## City of Ketchum

**Recommendation to review the additional materials requested of and submitted by the applicant, hold a public hearing and review any new testimony, and approve with conditions the PEG Ketchum Hotel Design Review**

**PROJECT:** PEG Ketchum Hotel, LLC or Ketchum Tribute Hotel or Ketchum Gateway Hotel

**FILE NUMBER:** P20-019

**1 LEVEL 1 MECHANICAL PLAN - A**  
1/8" = 1'-0"

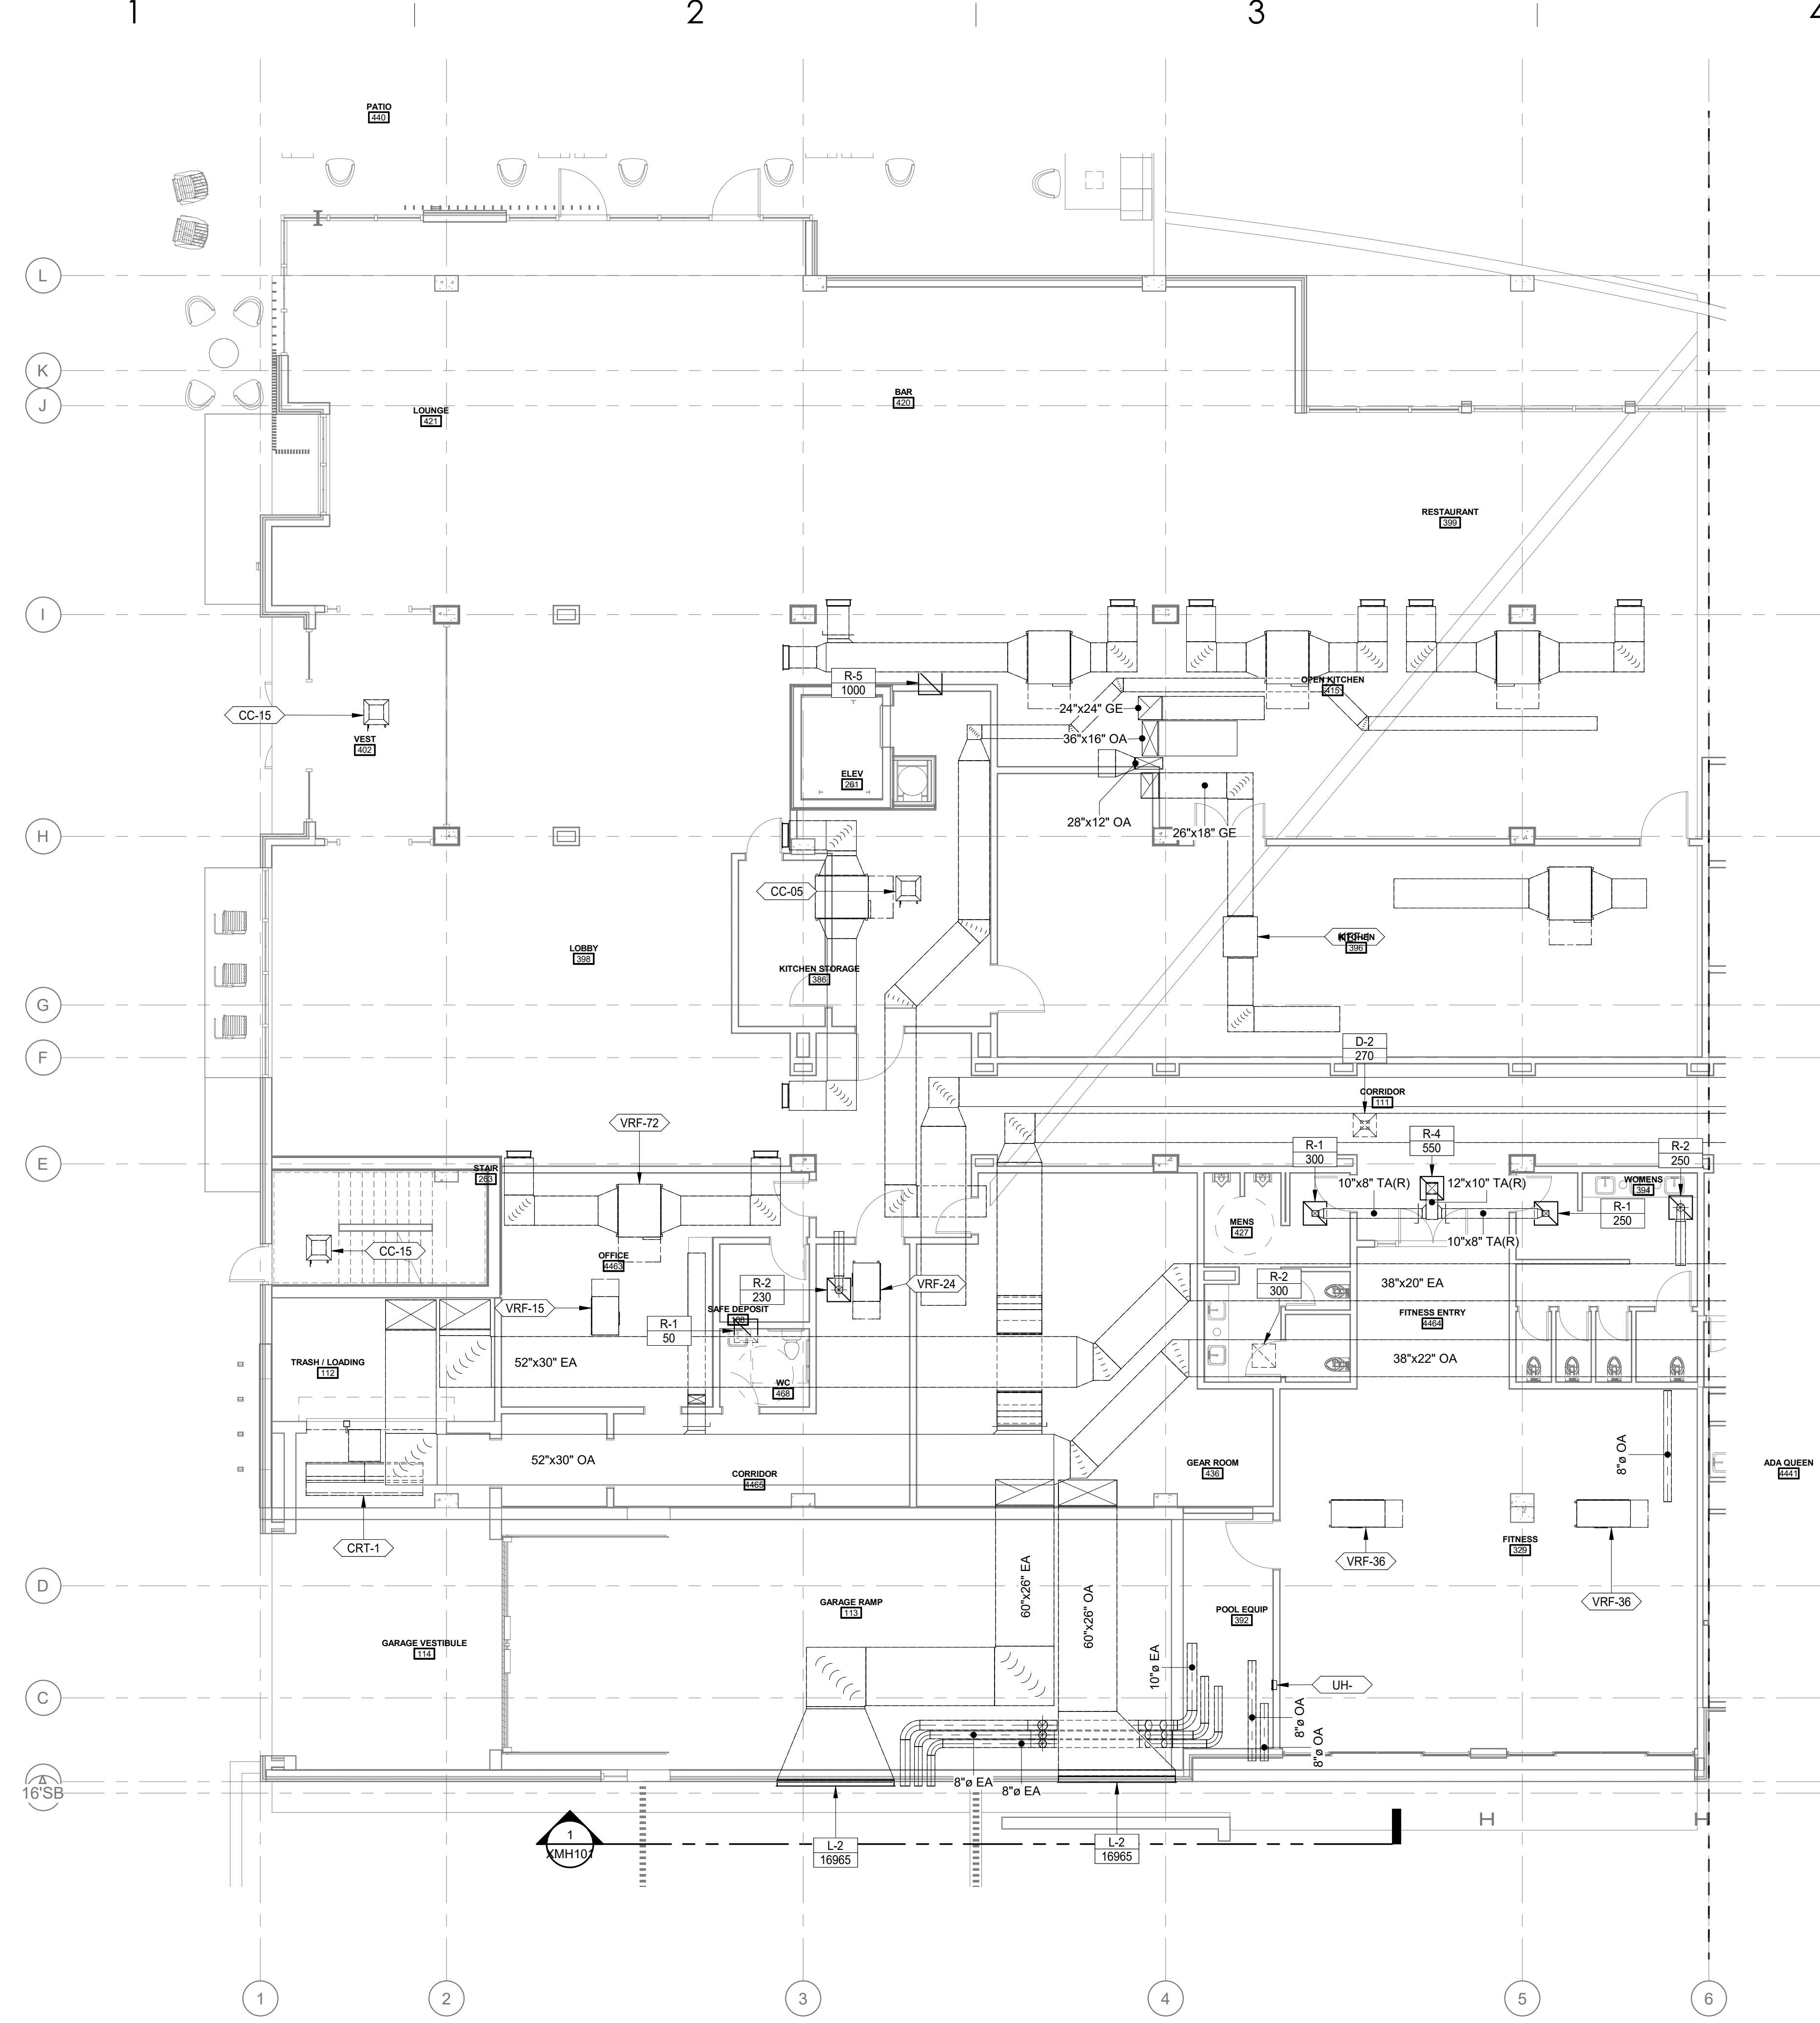
The level 1 portion of the West wall has the large ventilation ducts and louvers serving the building ventilation system. These louvers are tagged as L-2. These louvers will not have any smells, but will produce some noise. We anticipate these louvers to remain under 70 dB. Near louvers L-2, there are some round ducts penetrating the West wall of the building. These ducts are to serve the pool equipment and pool equipment room. These ducts will produce minimal to no smell and minimal noise. During times of cold weather, some of these ducts may produce steam.
